# *SERVICE BULLETIN*

PN: 20812798

**MODEL:** CAIRE HELiOS Marathon H850

**ISSUE:** Vent Valve Tube Assembly

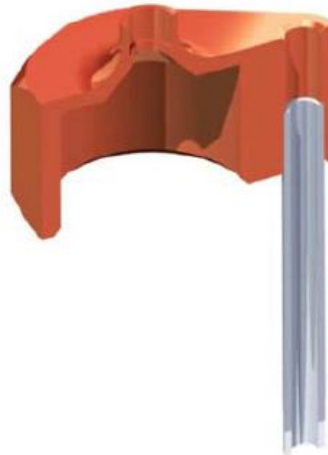
**NOTES:** The vent valve tube have a threaded connection to the QDV adapter as part of rolling changes to the HELiOS Marathon H850. This is a design improvement to the previous pressed-in connection that will make a more secure connection between the vent valve tube and the adapter. This is not a field replaceable component. This change will not affect the performance of the unit in any way.

The new part number for this assembly is: 20660433
